Cleveland City Planning Commission

March 20, 2026

Agenda: March 20, 2026

Mural Board Installation Process

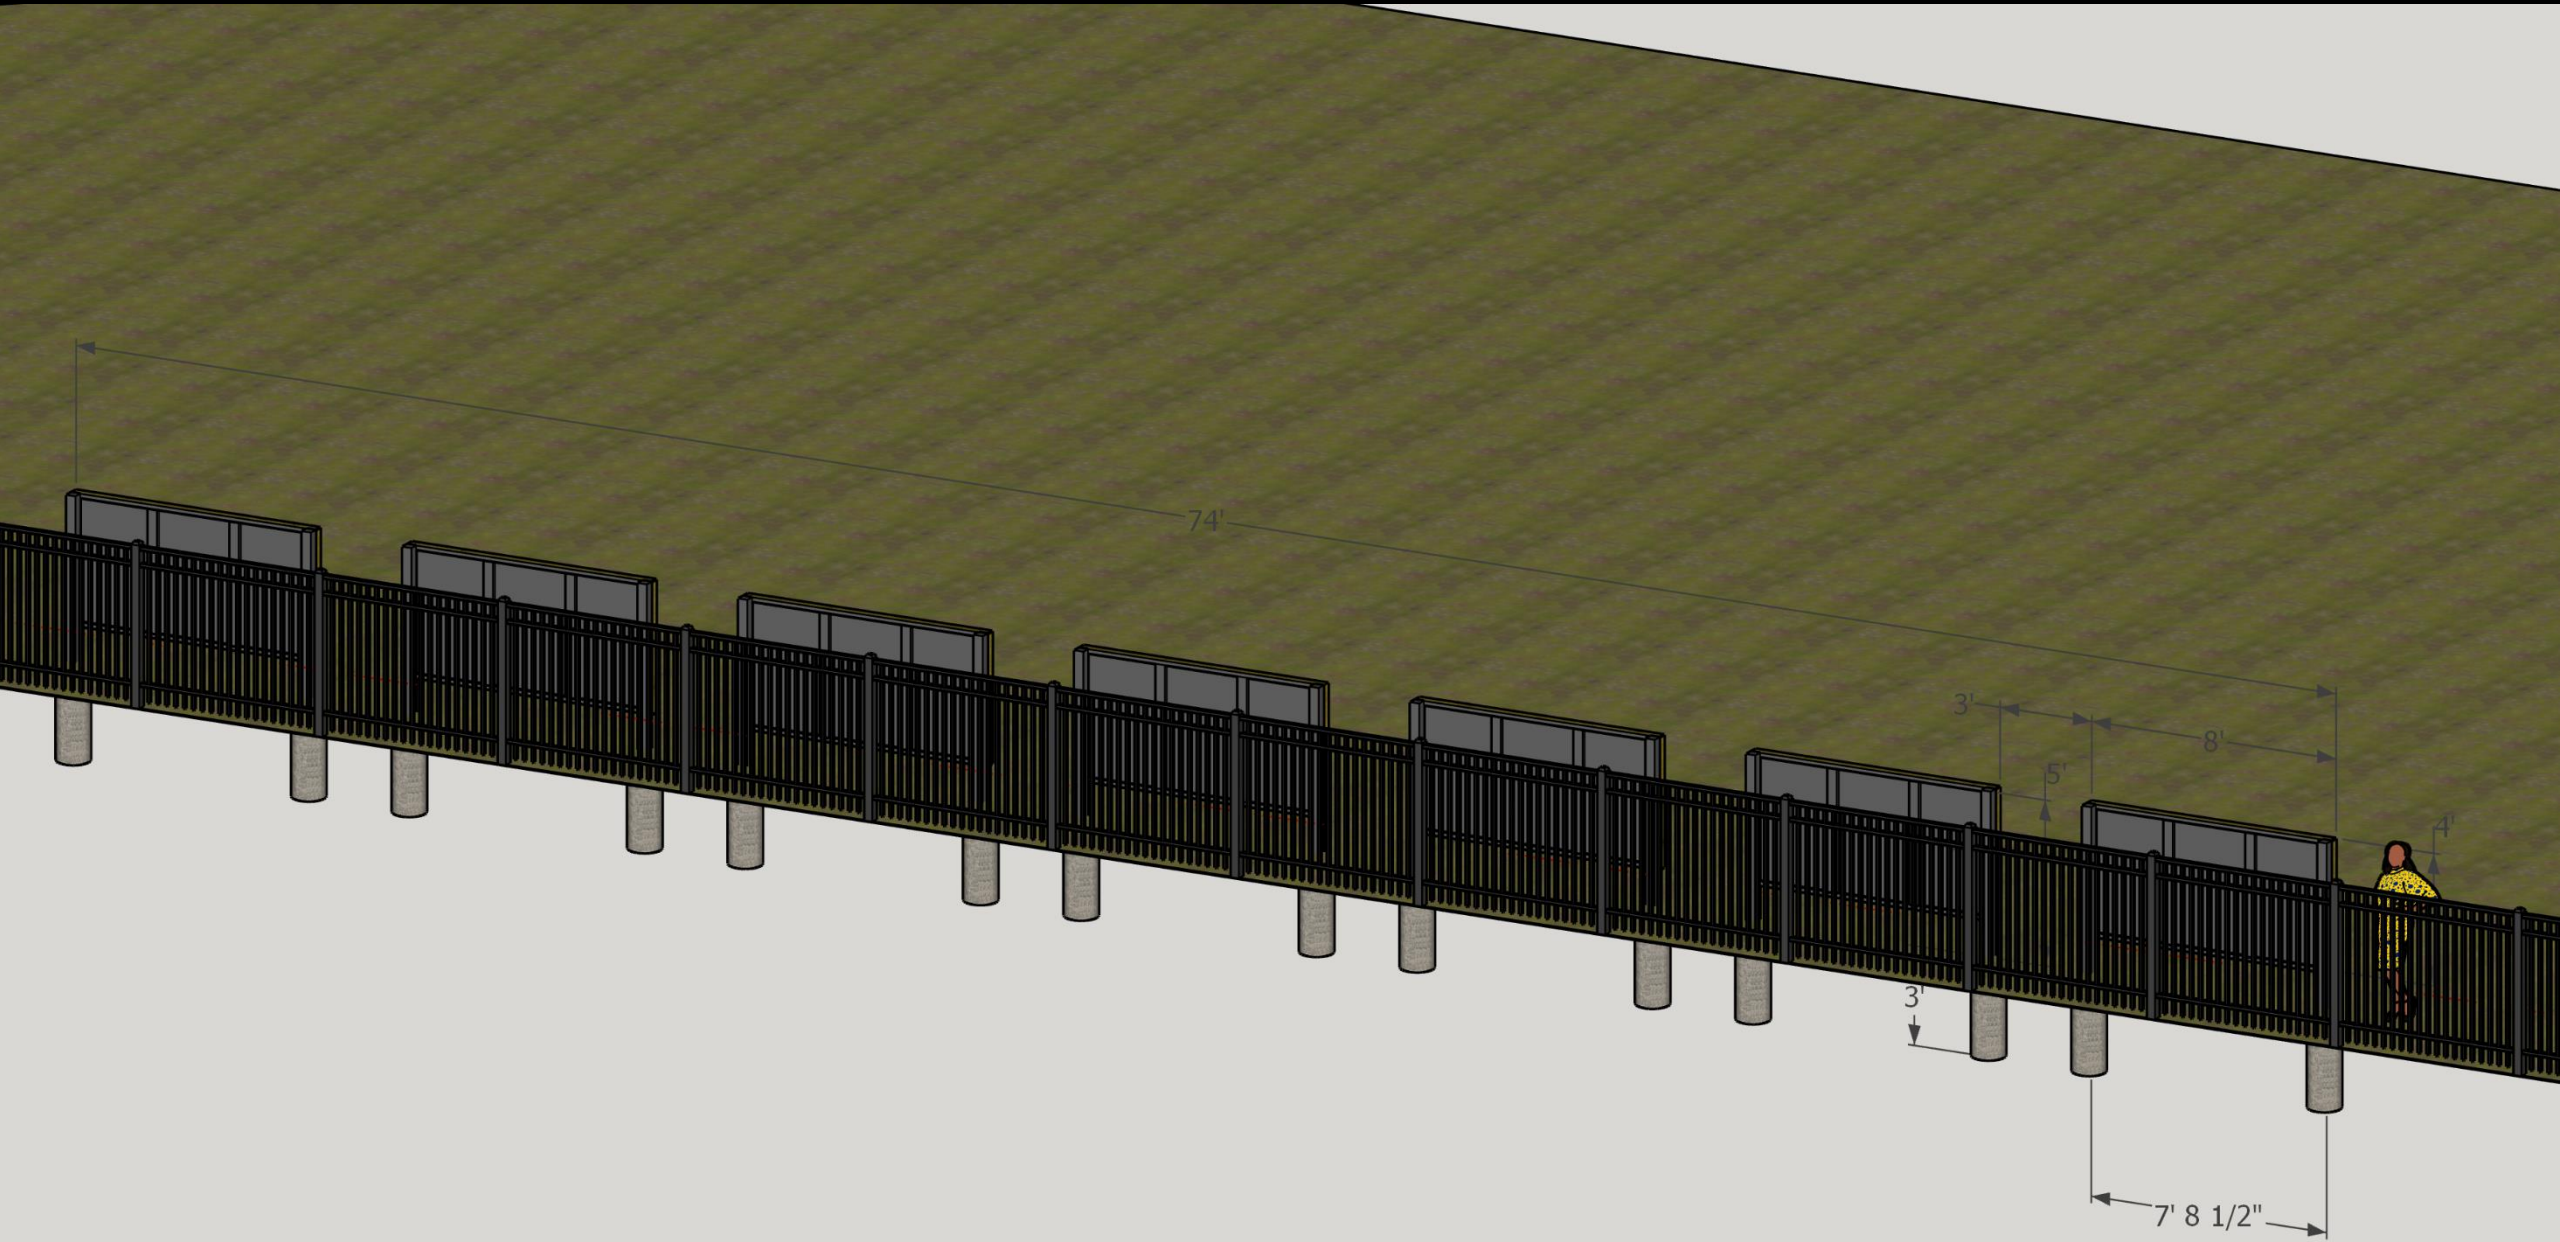
CEDRAC recommended final approval on 3/12/26 with the following conditions:

- Change color on back of mural panels to reduce contrast between fence and panels
- Space out panels to add visual permeability with potential to increase security
